HIGH PLAINS FILING NO. 1

CONSTRUCTION DOCUMENTS

PCD FILE NO: SP-18-003
SF-18-024

REV.	DESCRIPTION	DATE
1	ADDRESS AGENCY COMMENTS	09/27/18

HIGH PLAINS FILING NO. 1
 RALEIGH ROAD
 STREET IMPROVEMENT
 PLAN & PROFILE

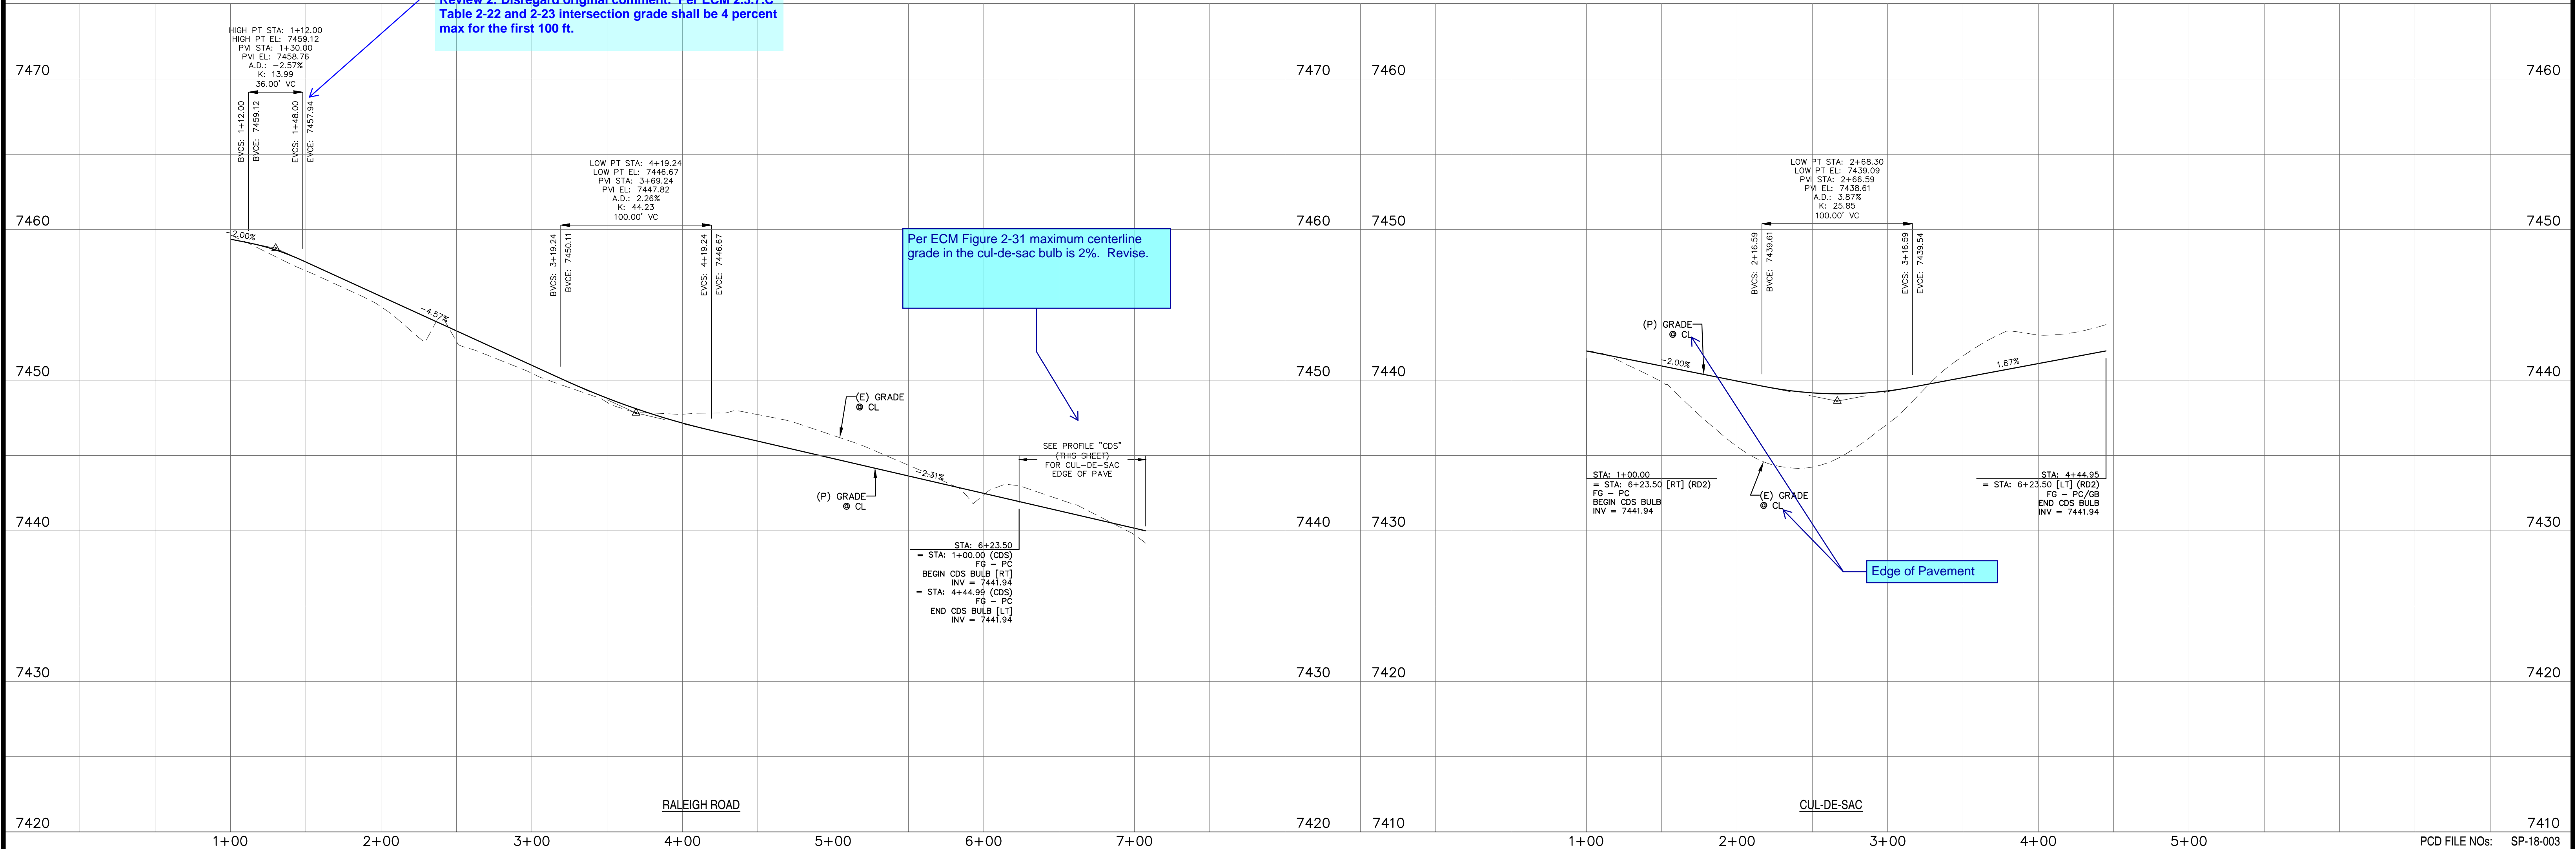
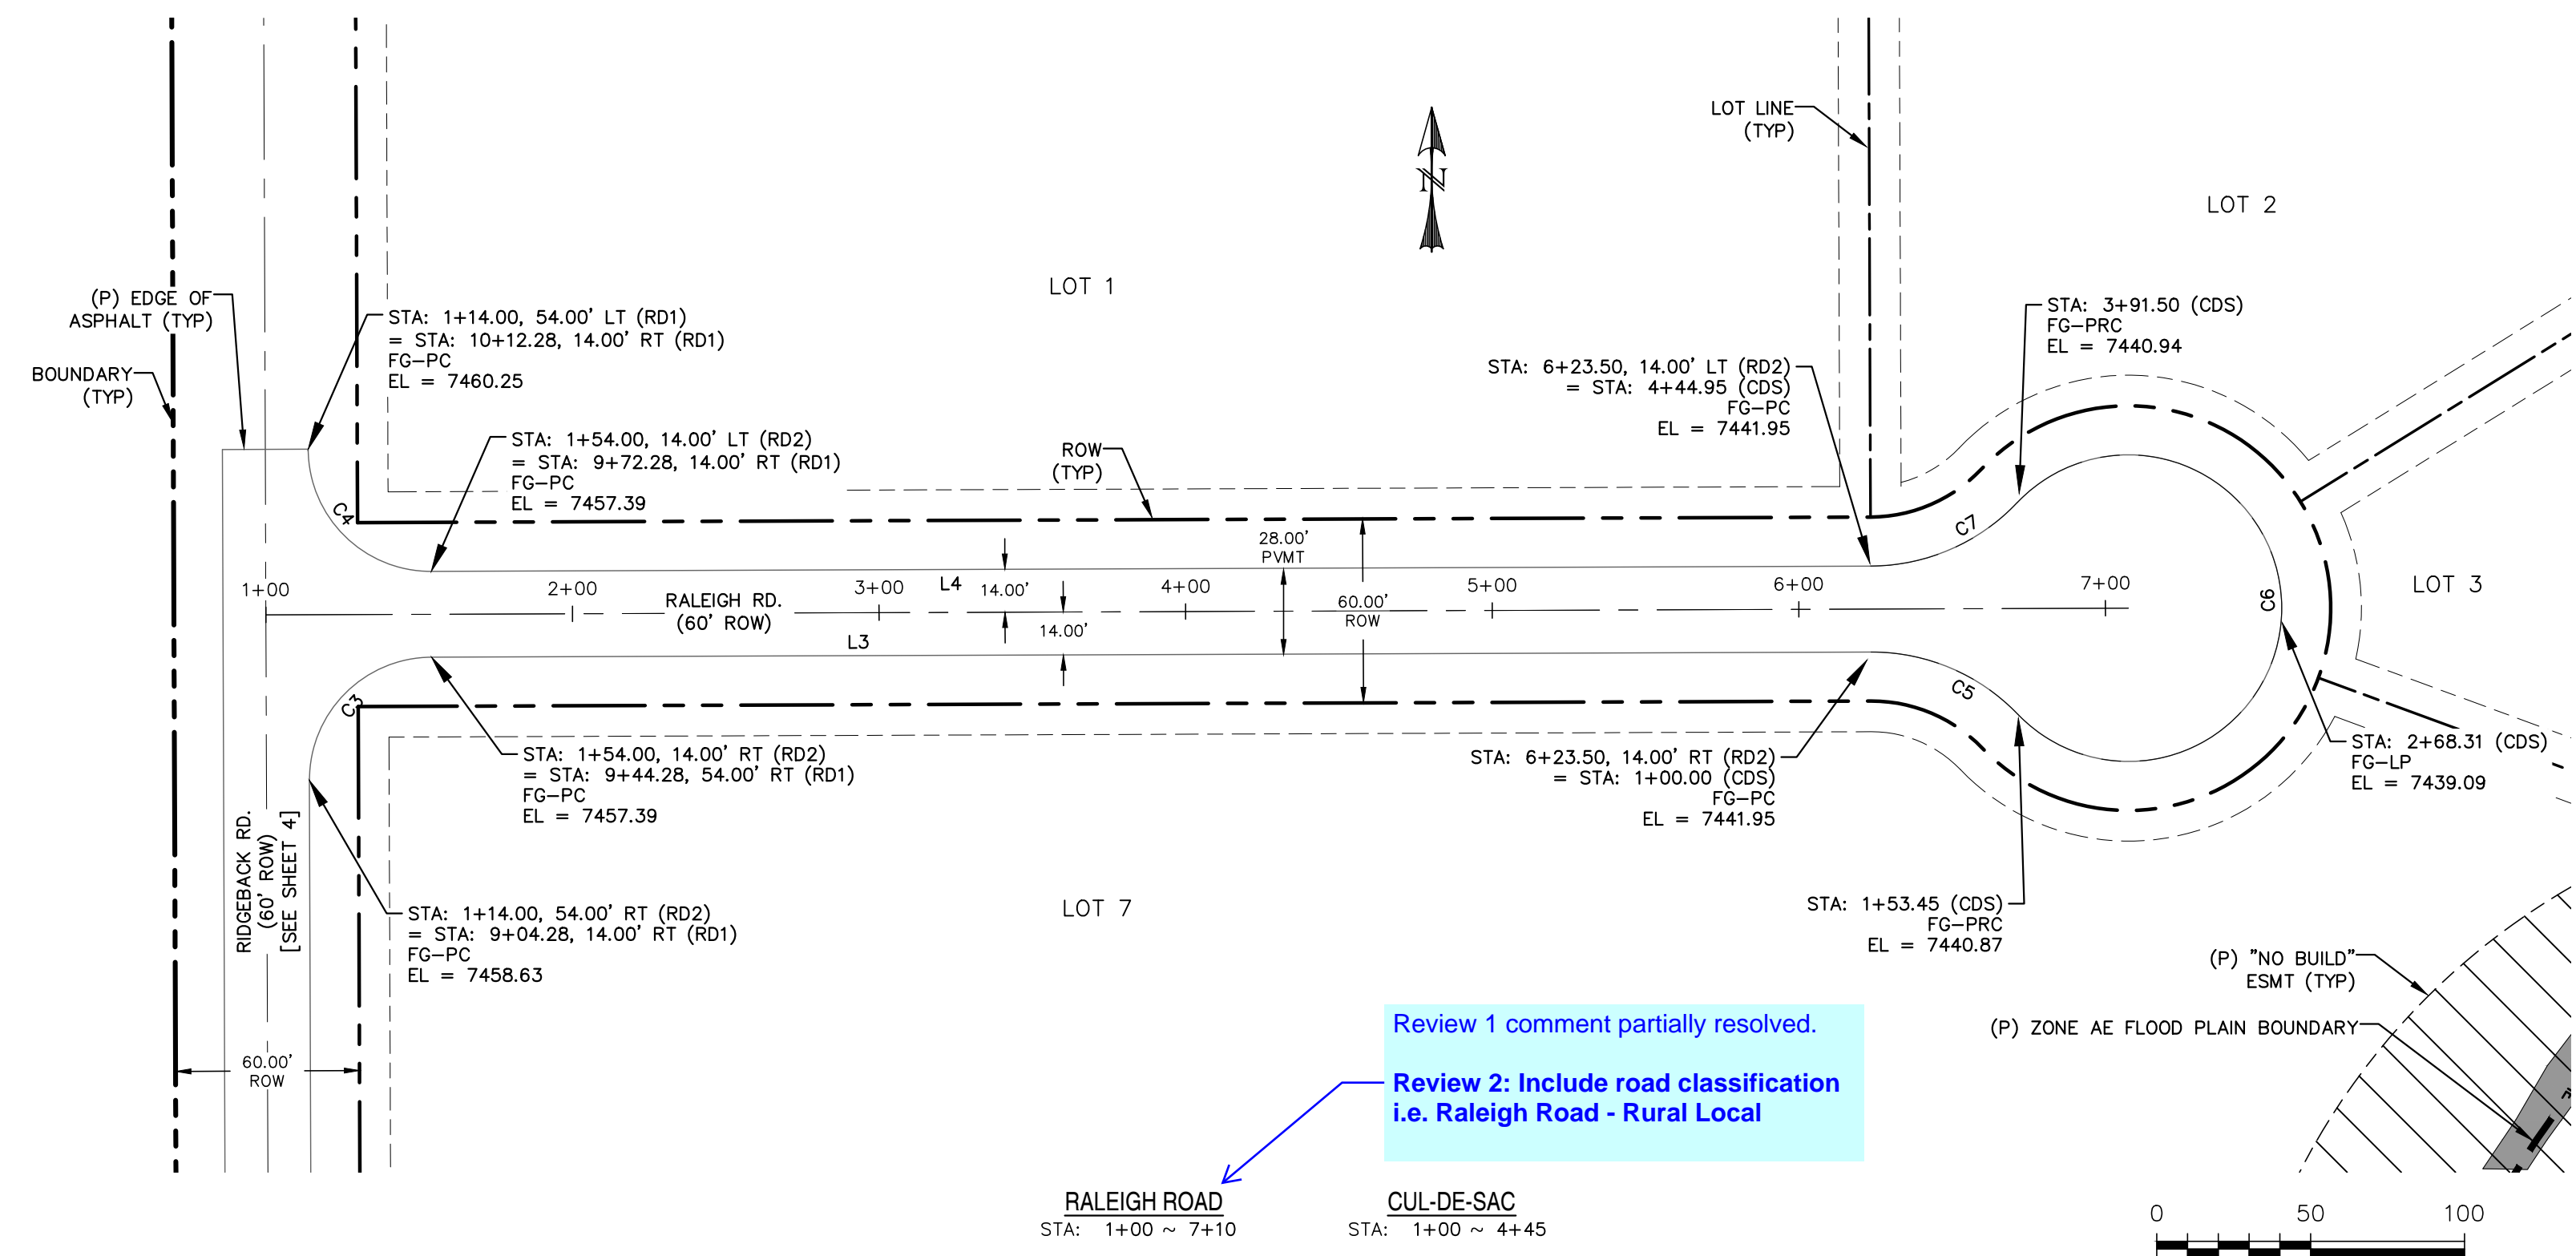
Review 1 comment partially resolved.
 Review 2: Include road classification
 i.e. Raleigh Road - Rural Local

Min. K=19 at crest vertical curves per ECM figure 2-19, typical.

Review 2: Disregard original comment. Per ECM 2.3.7.C Table 2-22 and 2-23 intersection grade shall be 4 percent max for the first 100 ft.

Per ECM Figure 2-31 maximum centerline grade in the cul-de-sac bulb is 2%. Revise.
